YESLER TERRACE BLOCK 5 | BLDG A

EAST DESIGN REVIEW BOARD

DESIGN RECOMMENDATION MEETING #2

209 12TH AVE S | PROJECT #3026743

STORMWATER PLAN DIAGRAM

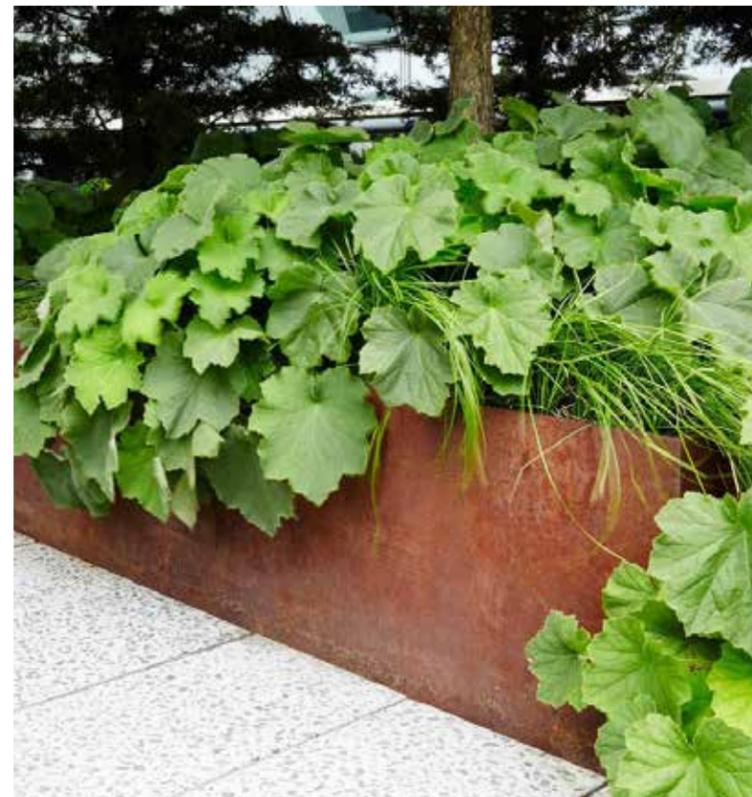
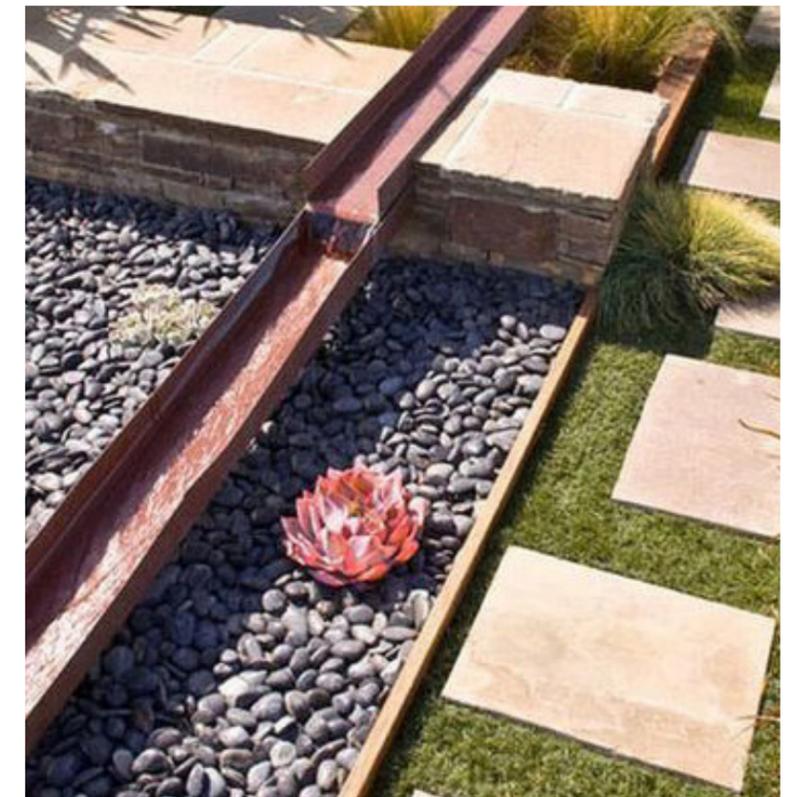
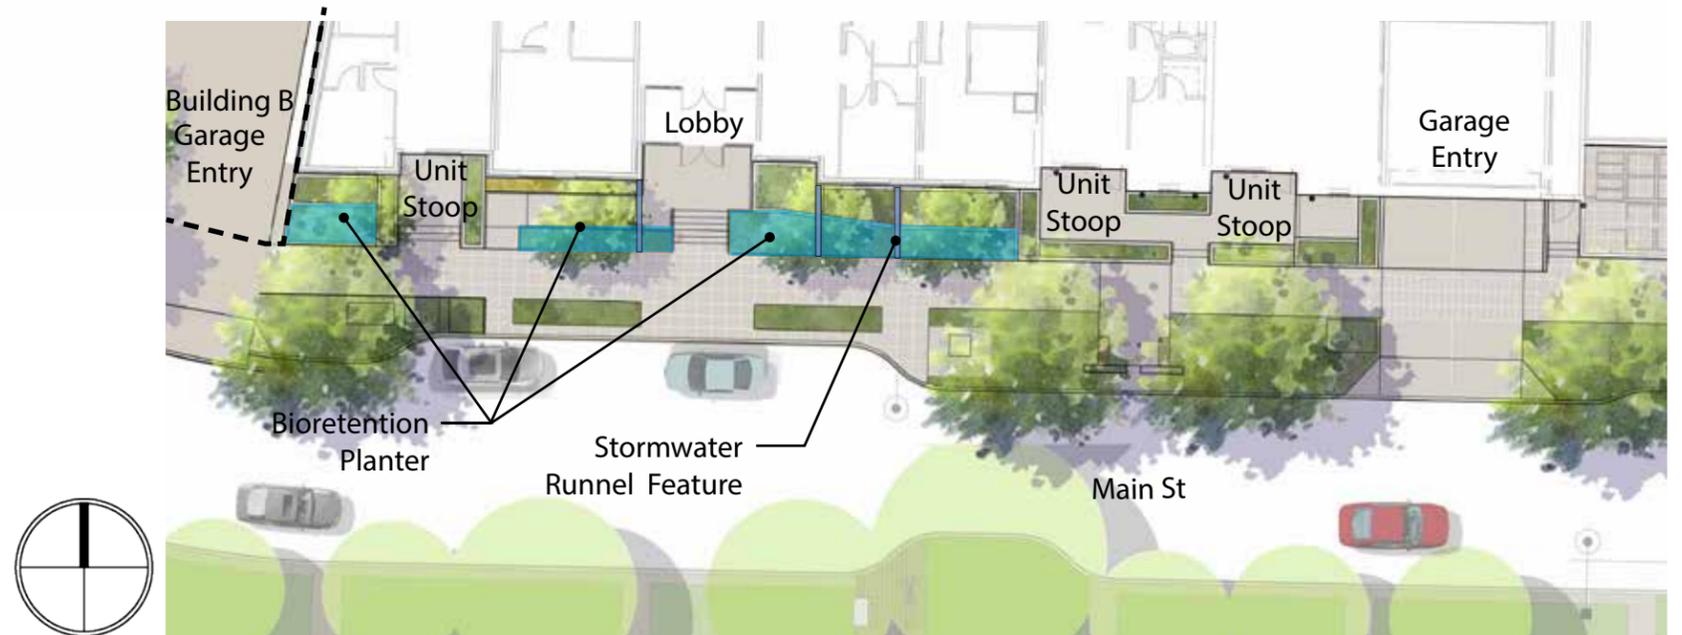
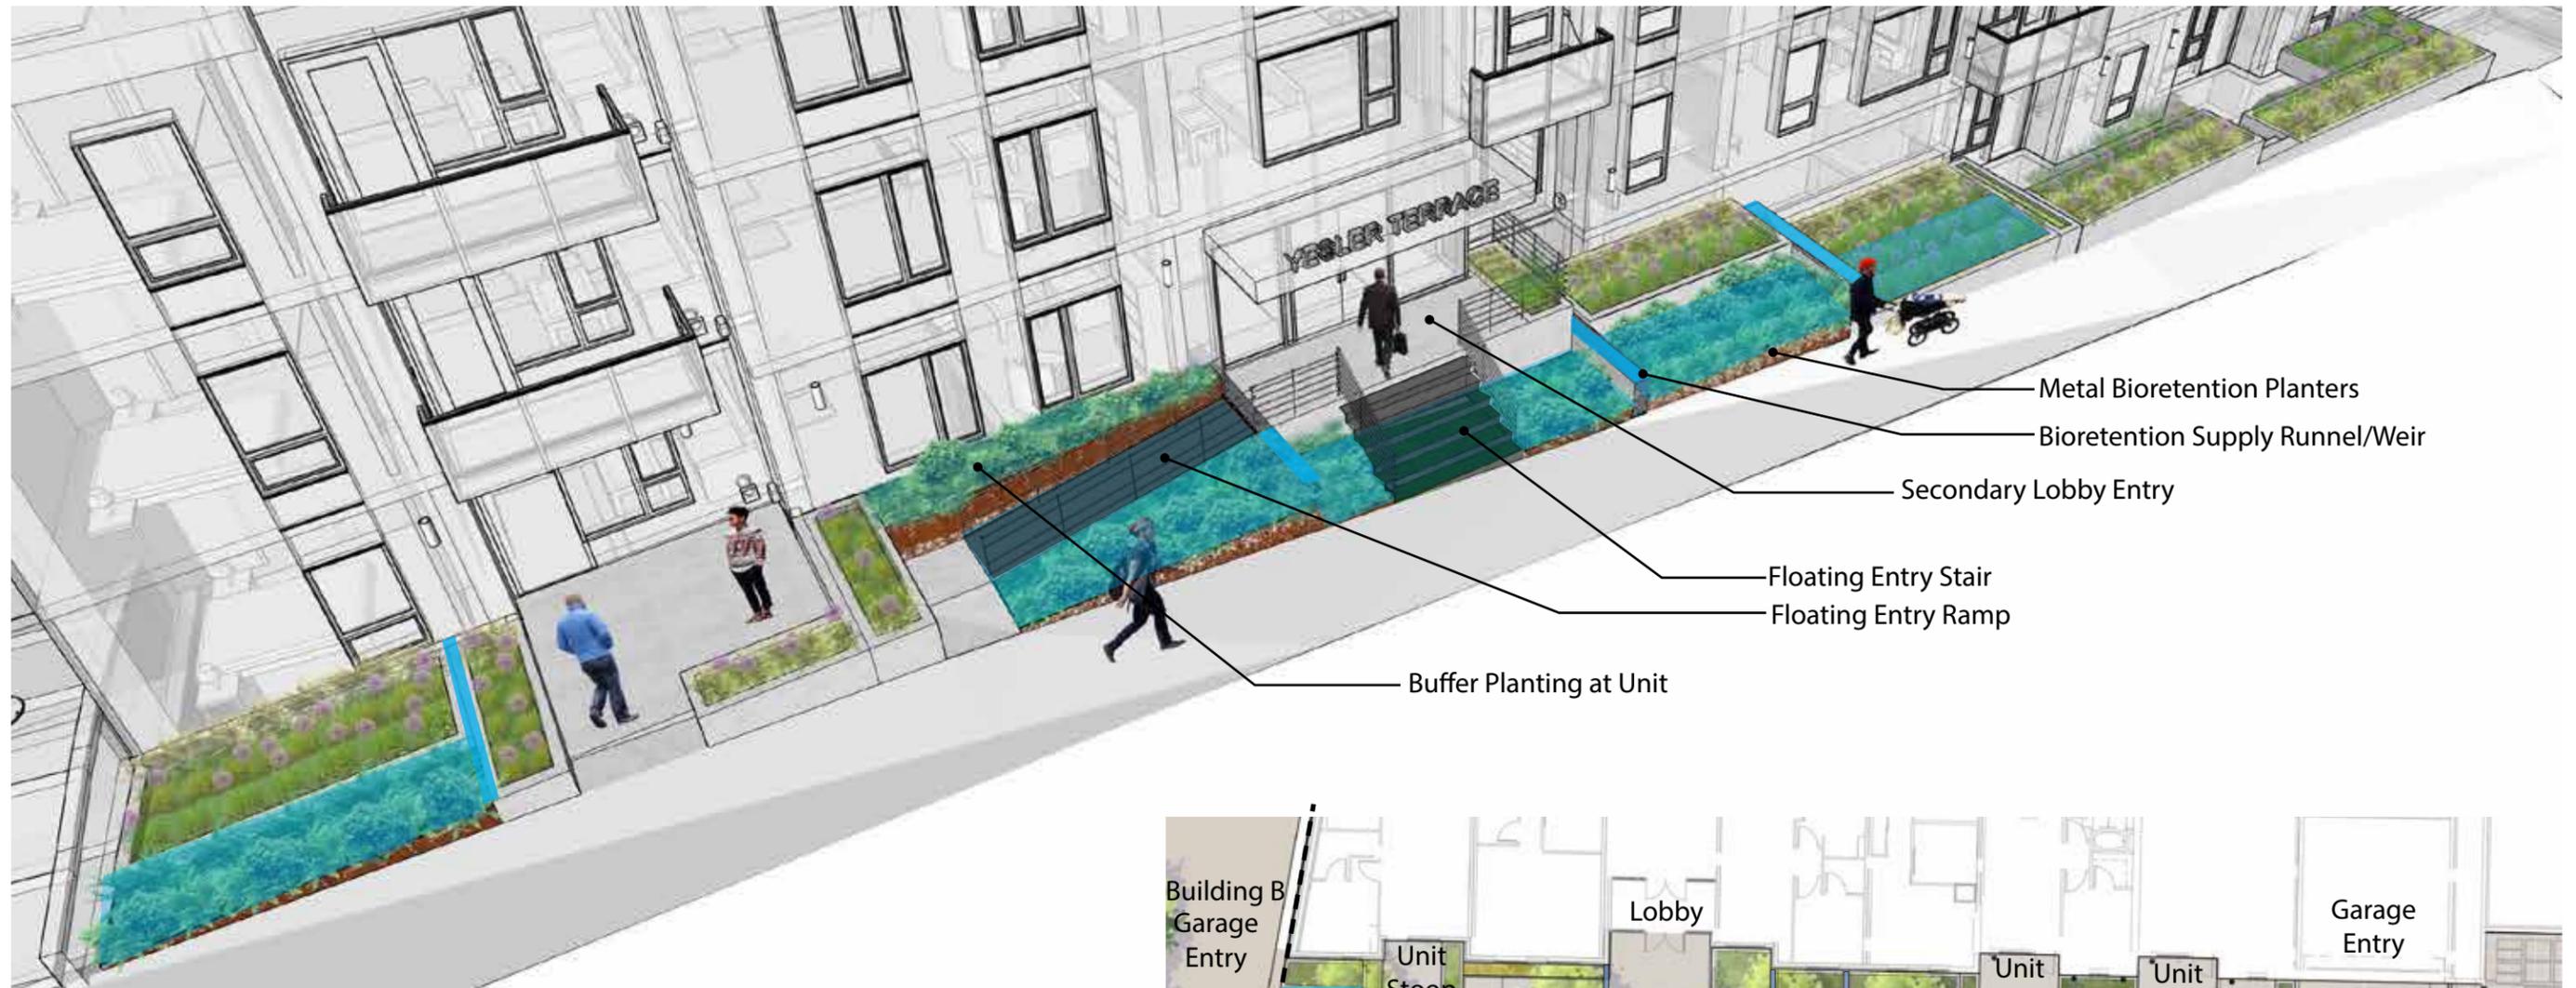
REC 1 meeting for Building A: (5.) The Board supported the proposed bio-retention and stormwater planters near the S Main St sidewalk and recommended extending bioretention planters to the West and exploring cascading features to take advantage of the site topography and create visual interest for the pedestrian.

This concept both addresses stormwater management in environmentally responsible ways and creates expressive landscape that celebrates stormwater. Bioretention planters along S Main Street are repositioned and realigned to foster a greater public interest and enjoyment in a cascading form. Planters are allowed to step with site grade and continue under Lobby stair to allow moments of curiosity and varied perspectives.

Runnel/weir elements transport stormwater away from the building into bioretention planters. Runnels' layout compliments building edges and plant realignment.

DEPARTURE
UNIT PATIO SECTION @ MAIN ST

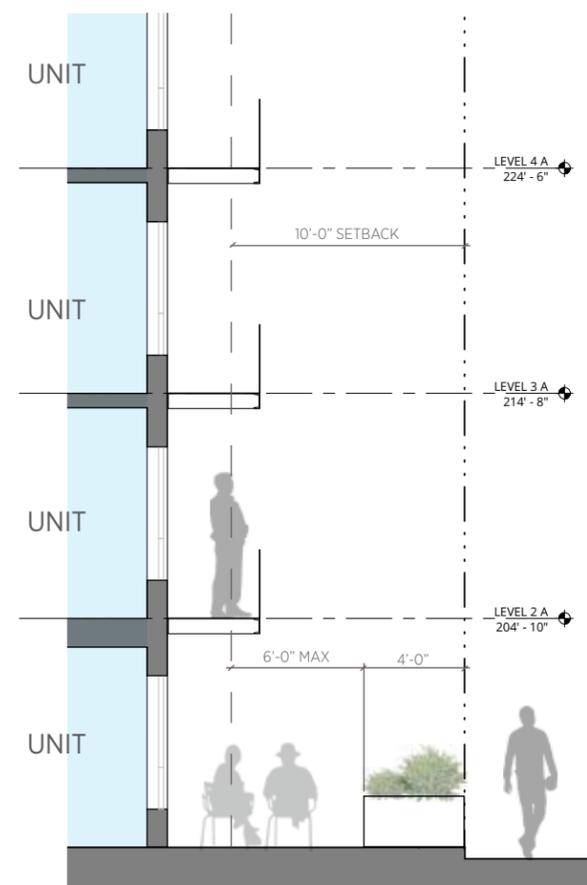
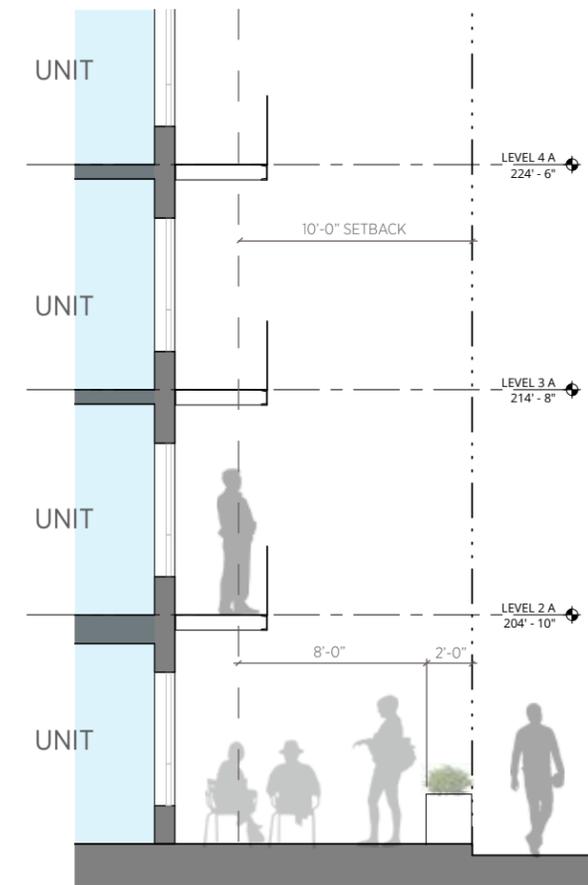
Provide patios for residential access which project beyond 6 feet into the required setback. Edge of patios are 2ft minimum away from a boundary line. The departure request occurs at the ground level patios along the South facade, Main St.
